REMARKS

In the Office Action dated December 19, 2002, the response time to which has been extended by one month until April 21, 2003 (April 19, 2003 falling on a Saturday) by a concurrently filed Request for a One Month Extension of Time and fee, the drawing are objected to. Claims 1-8 are rejected under 35 USC §103(a). Claim 6 is objected to, but indicated as being allowable if rewritten in independent form.

Fig. 2

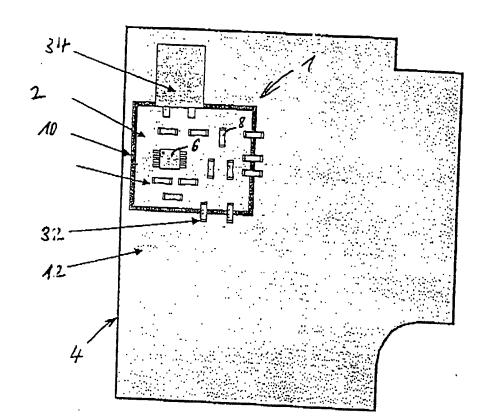
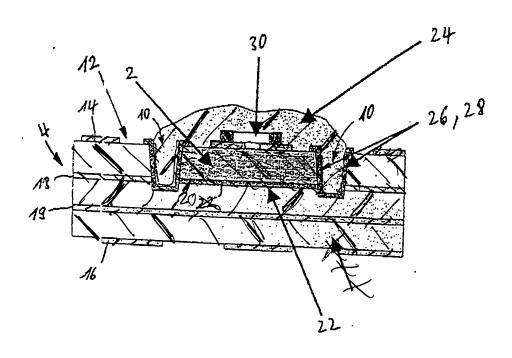
The drawings are objected to for improper cross hatching and the lack of reference number 20 in Fig. 2.

Accordingly, proposed drawing corrections are submitted herewith and show in red proposed cross hatching corrections and the inclusion of reference numeral 20 in Fig. 2.
